**SECTION 00 90 01
BIDDING AND CONTRACT REQUIREMENTS
ADDENDUM NUMBER (04)**

Issued: May 6, 2024

Bid 24-032 Elgin Sports Complex Expansion

Architect's Project Number: 14106

DRAWING NUMBER
CU-102

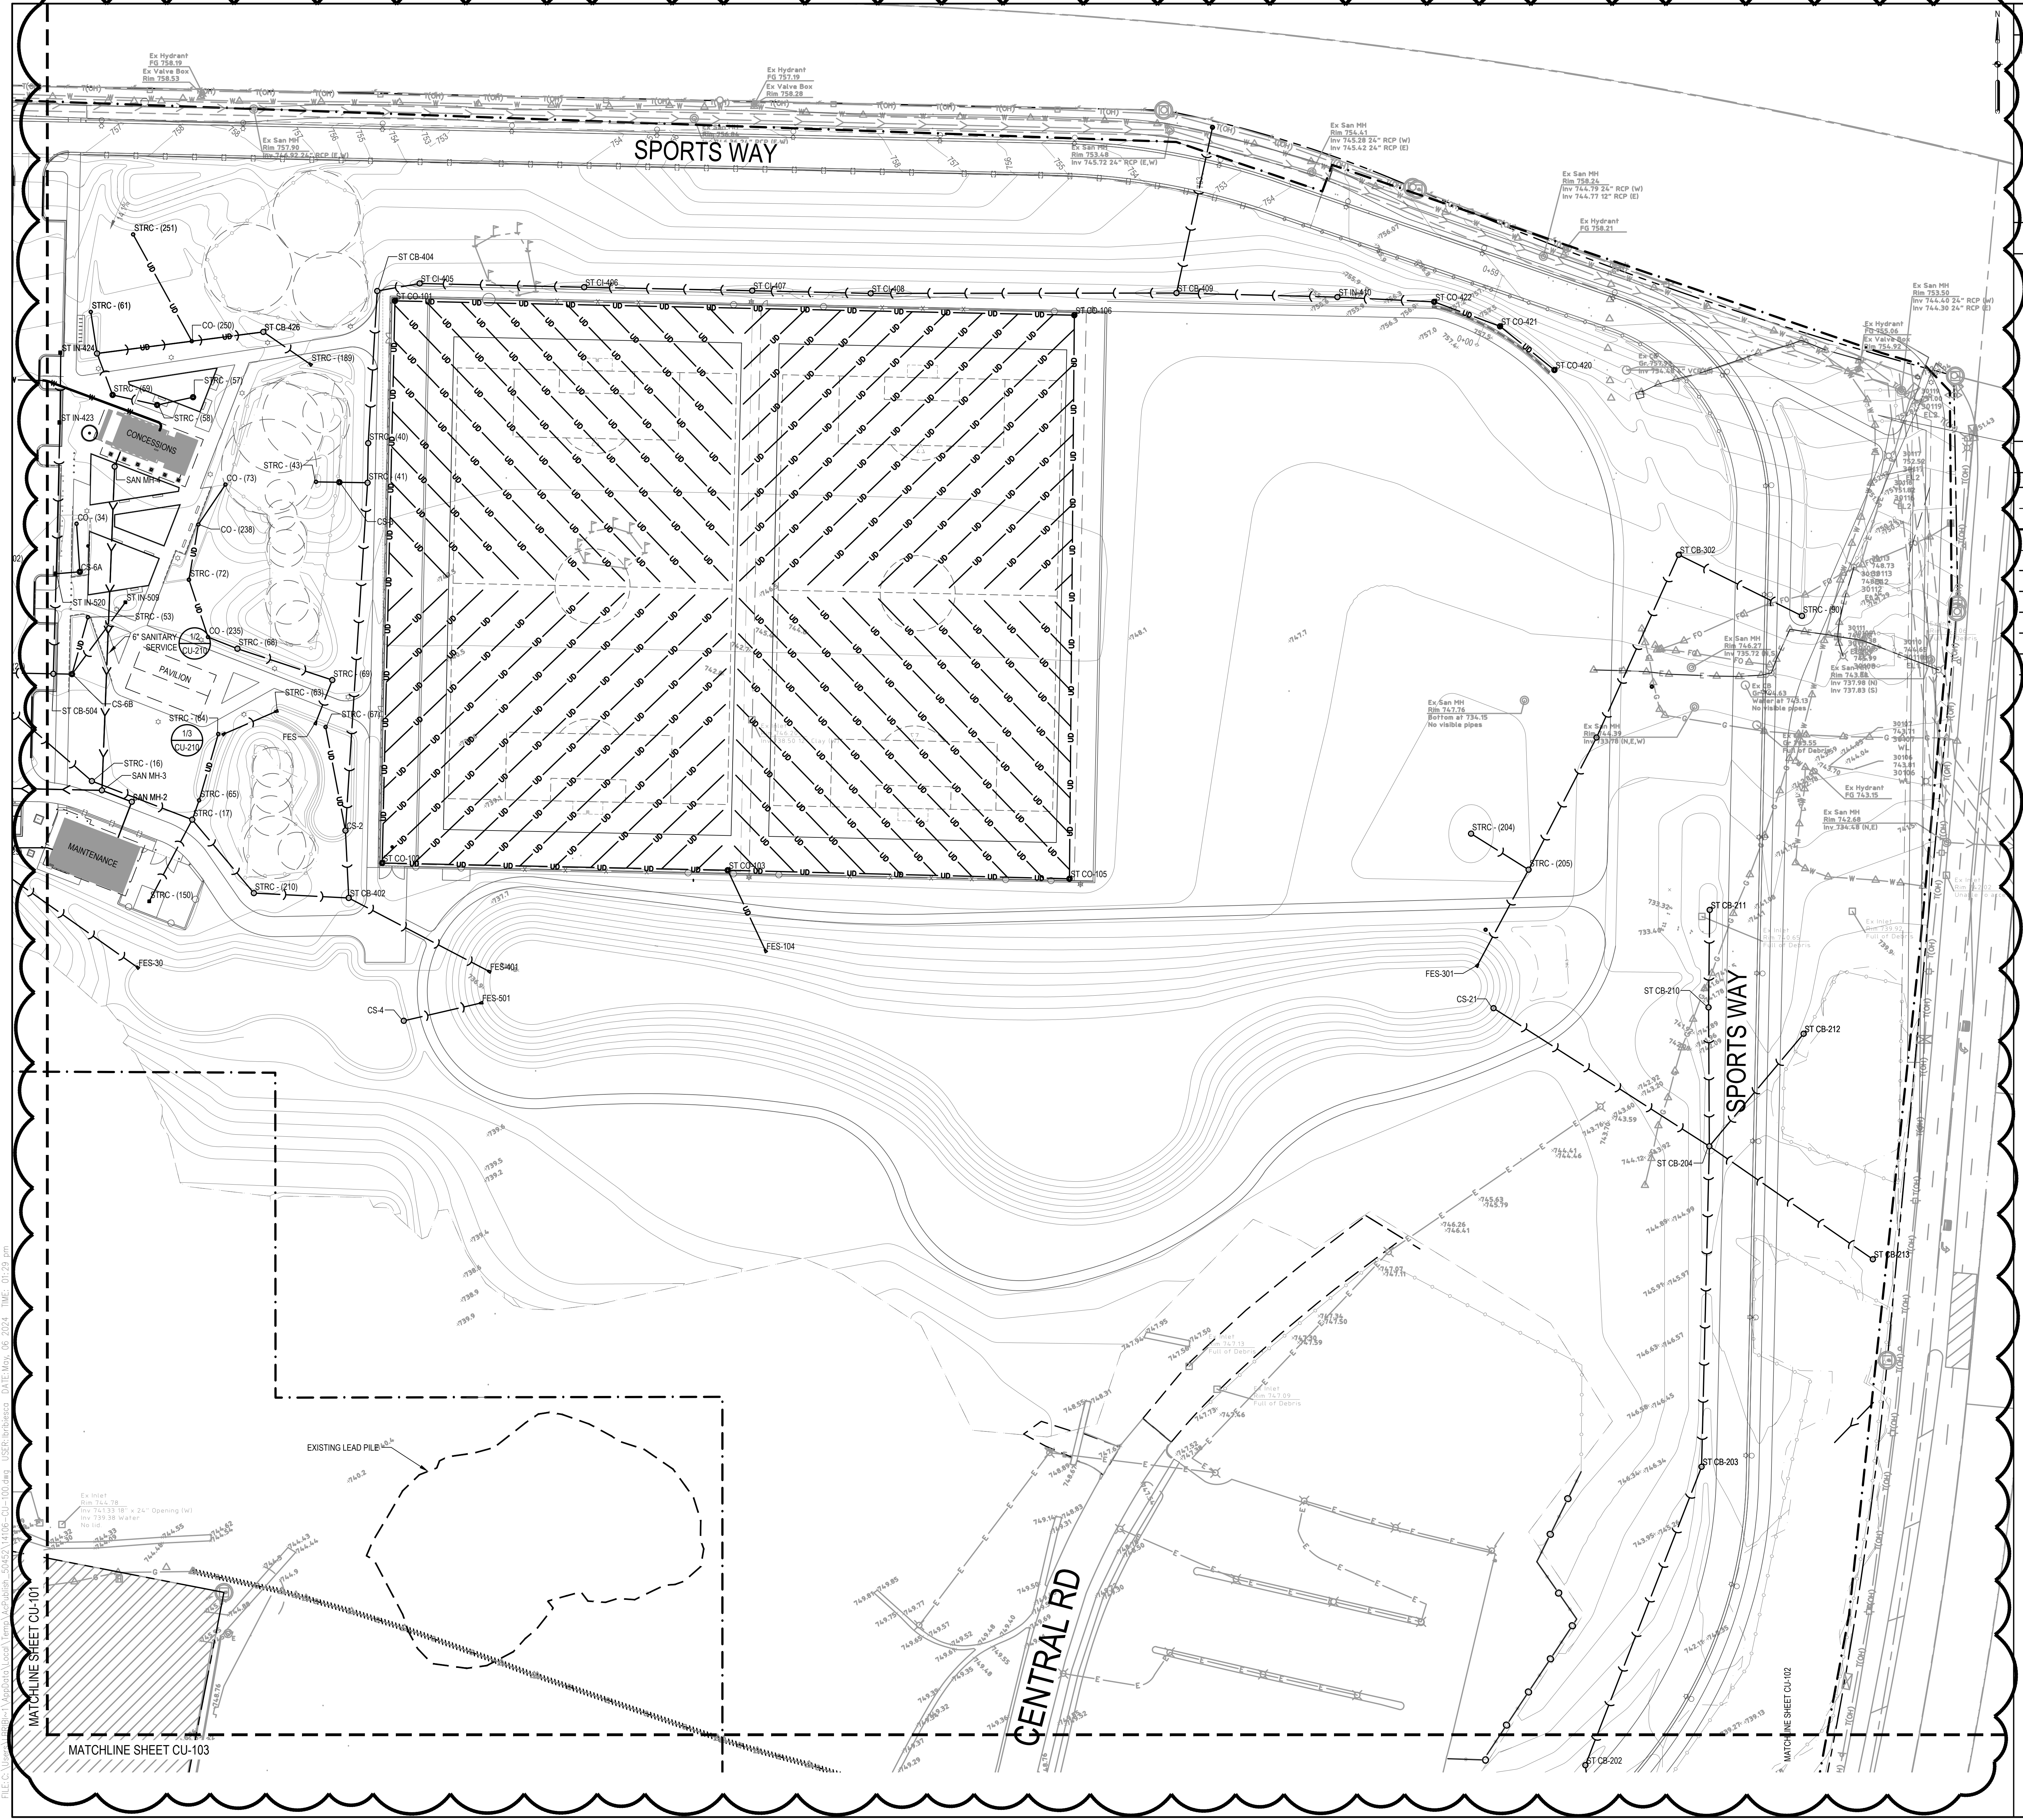
2. Description: On pages CU-101 Thru CU-103 the storm structures are shown but not labeled with any sizing, description, rim, invert or frame and lids. Some structures have the type of structures, some have everything, and some are not labeled. The Sanitary structures are all called out on pages CU-204 & 205. CU-206 is labeled Watermain Plan and Profile and shows some storm structures but not all. Will there be a revision including the structure sizing with rims, inverts, frames and lids? **See updated CU sheets in Addendum 4**

1. CU-100 through CU-103 – UTILITY PLAN: updates to storm drain, water and sanitary systems as indicated on the plans. Additions include control structures to bioswale facilities and Detention Ponds A & B, addition of culvert to convey runoff north of Sports Way to Detention Pond A, removal of 1 section of mainline storm drainpipe (AREA C) and extension of existing storm drain system that connects to Detention Pond B.
2. CU-201 through CU-203 – STORM SEWER PLAN AND PROFILE: updated to address revisions to the design layout, and to include pipe materials.
3. CU-208 through CU-214 – STORM SEWER PLAN AND PROFILE: added profiles to provide design information for portions not previously released.
4. New Sheet - ALT-200 - ALTERNATE 2 - ATHLETIC FIELD 3 IRRIGATION (See sheets issued in Addendum 3)
5. New Sheet - ALT-201 - ALTERNATE 8 - CORE AREA IRRIGATION (See sheets issued in Addendum 3)
